**Section 16 Planning Application for Proposed Amendments to the Approved Master Layout Plan of Ma Wan Park Development at Ma Wan Lot Nos. 48, 114, 229 RP and 684 (Part) and Adjoining Government Land (Application No. A/I-MWI/48)**

**Responses-to-comments Table**

**Section 16 Planning Application for Proposed Amendments to the Approved Master Layout Plan of Ma Wan Park Development  
(Planning Application No. A/I-MWI/48)**

<b>Figure:</b> 5-1	<b>RAMBOLL</b>	
	Drawn by:	KK
	Checked by:	TC
	Rev.:	1.0
<b>Date:</b> Dec 2024

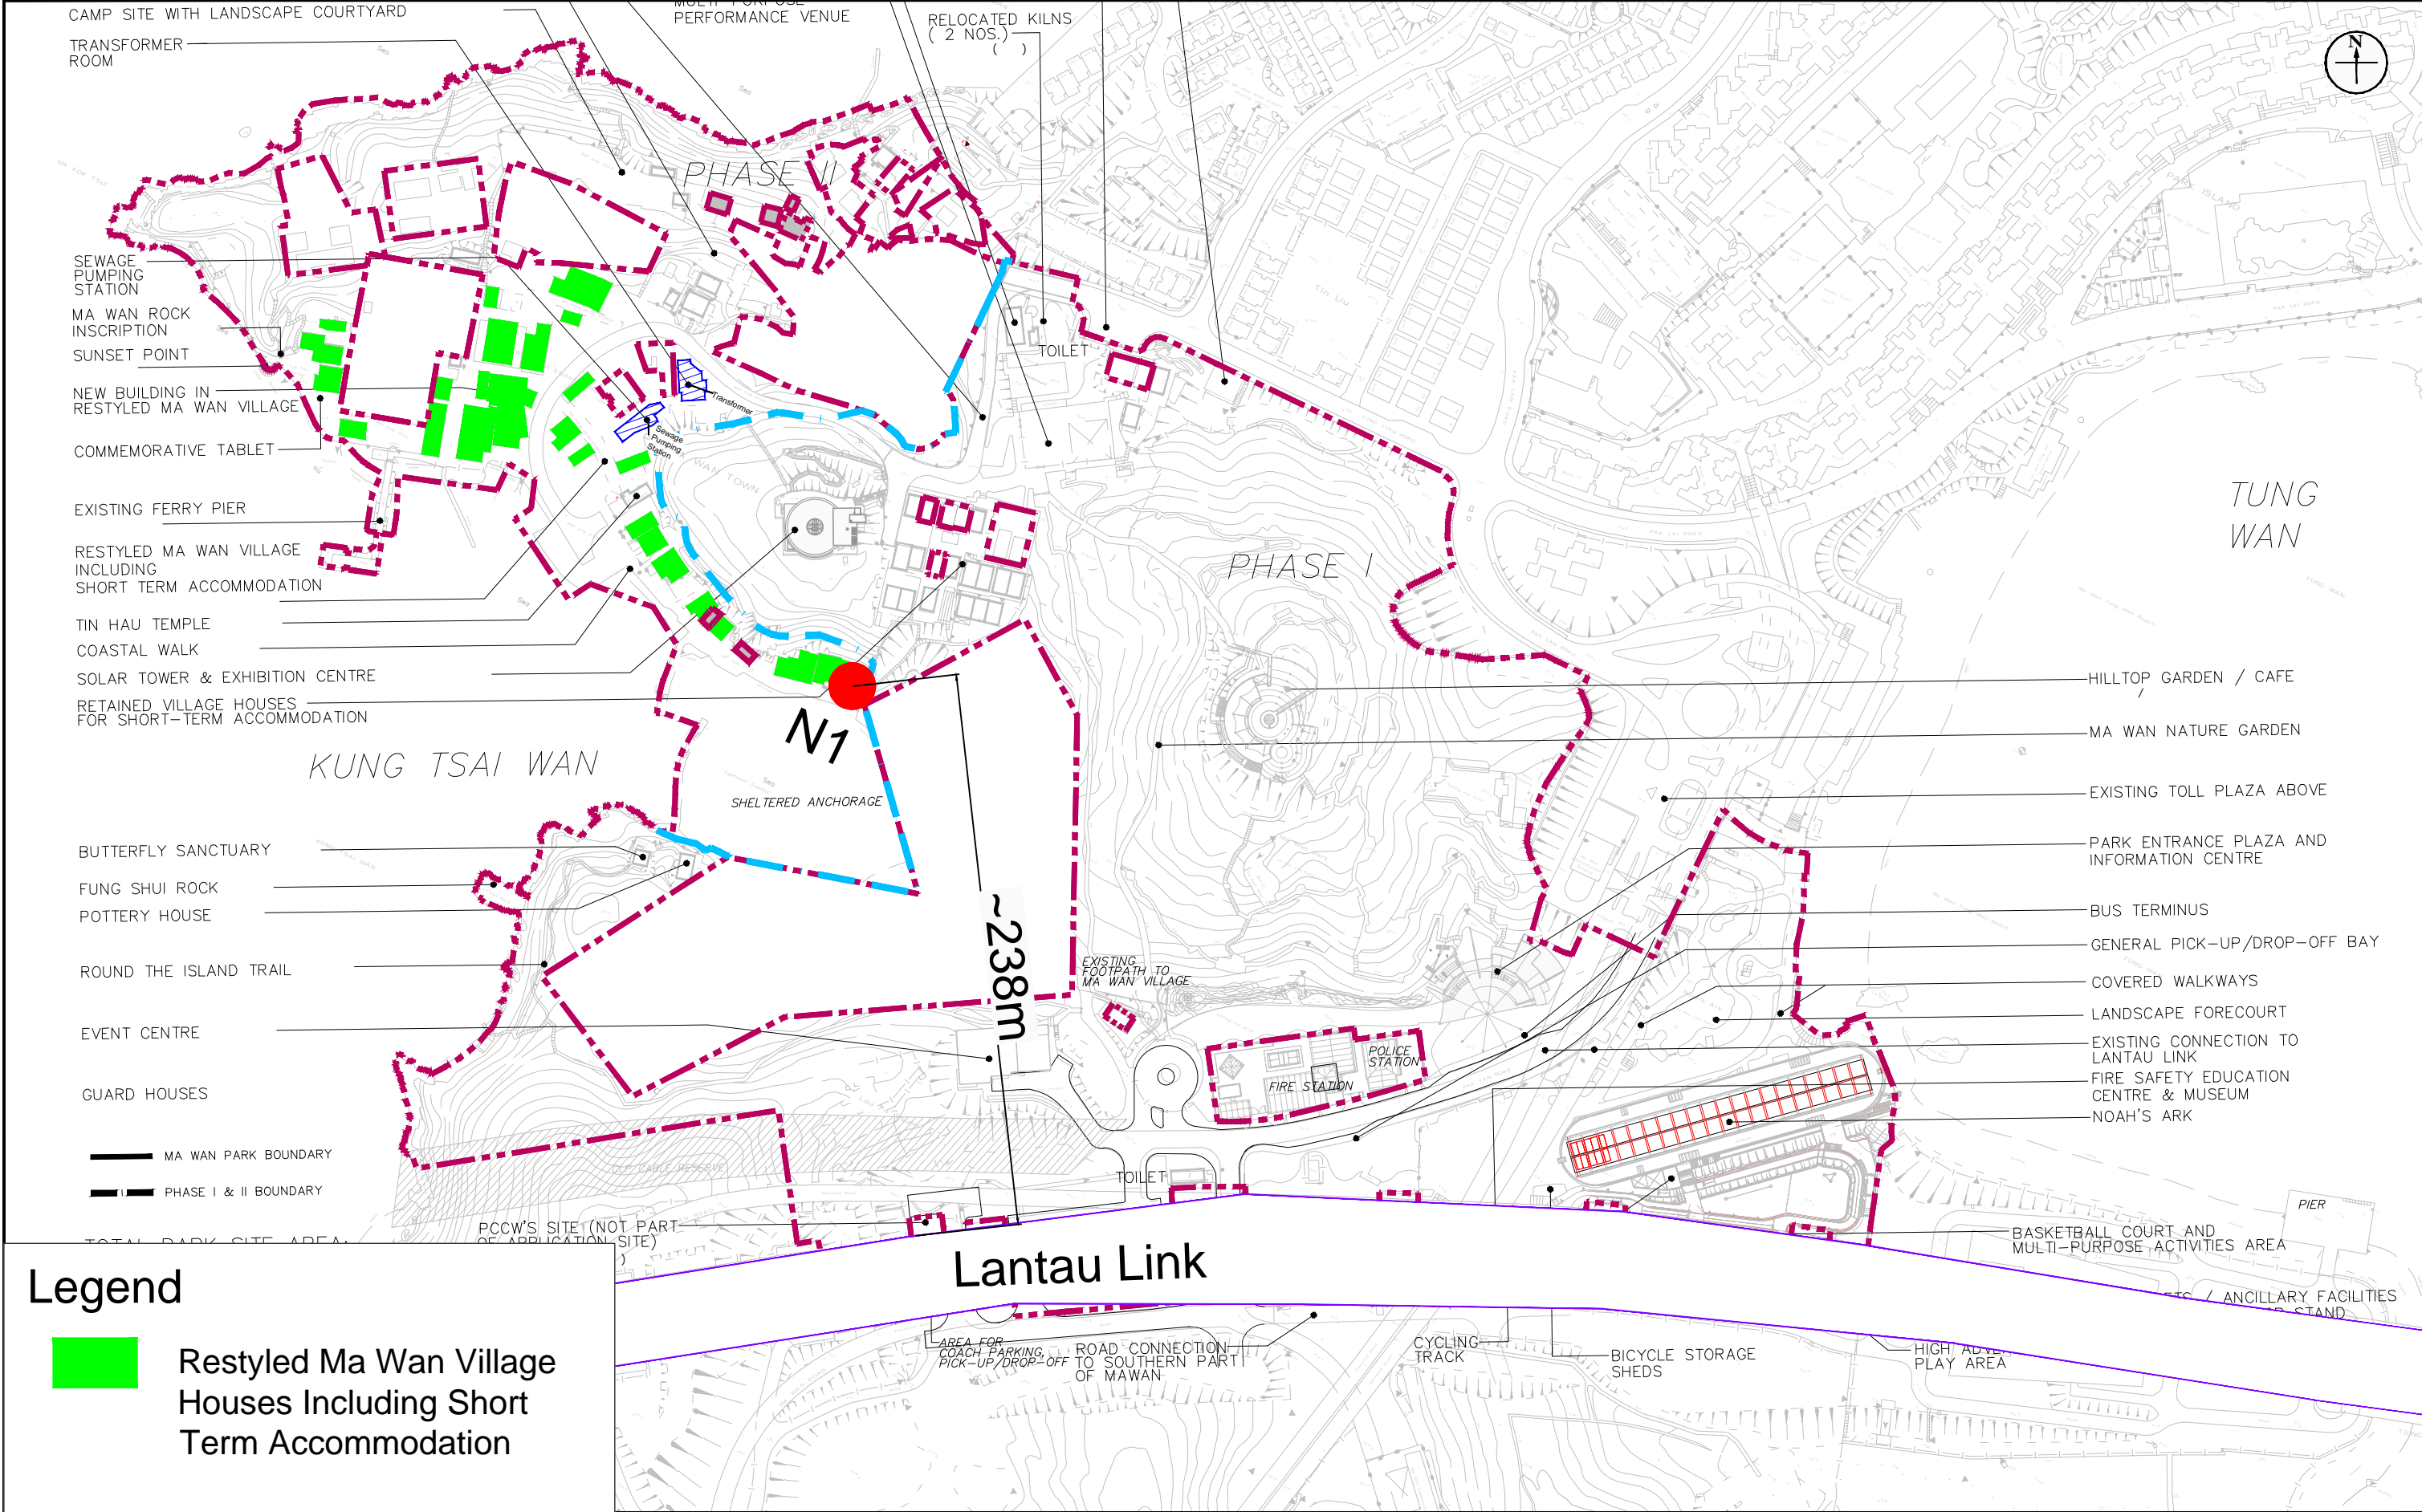
1.2	<p><b><u>Tin Hau Temple (Grade 3)</u></b></p> <p>The Tin Hau Temple (Grade 3) is indicated as “<u>Restyled Ma Wan Village Houses including Short Term Accommodation</u>” in Figures 1-1, 2-1, 3-1, 4-1 and 5-1 of Appendix E of the Preliminary Environmental Review of the current pre-submission. However, according to the accepted Preservation and Restoration Proposal for Tin Hau Temple, Ma Wan (November 1, 2023 version), which contributed to the partial fulfilment of approval condition (n) under Planning Application No. A/I-MWI/45, Tin Hau Temple will be <u>kept empty and opened to public for appreciation</u>.</p>	<p>Please note that it is an editorial error to include Tin Hau Temple as “Restyled Ma Wan Village Houses including Short Term Accommodation”. Figures 1-1, 2-1, 4-1 and 5-1 of Appendix E of the Preliminary Environmental Review have been revised to exclude the Tin Hau Temple accordingly (see <b>Attachment 2</b>). Please also note that Figure 3-1 as mentioned in paragraph 2.2.2 of the Preliminary Environmental Review is a typo. It shall refer to “Figure 2-1” instead. The replacement page has also been provided in <b>Attachment 2</b>.</p> <p>Please be clarified that the Tin Hau Temple will be kept empty and opened to public for appreciation in accordance with approval condition (n).</p>
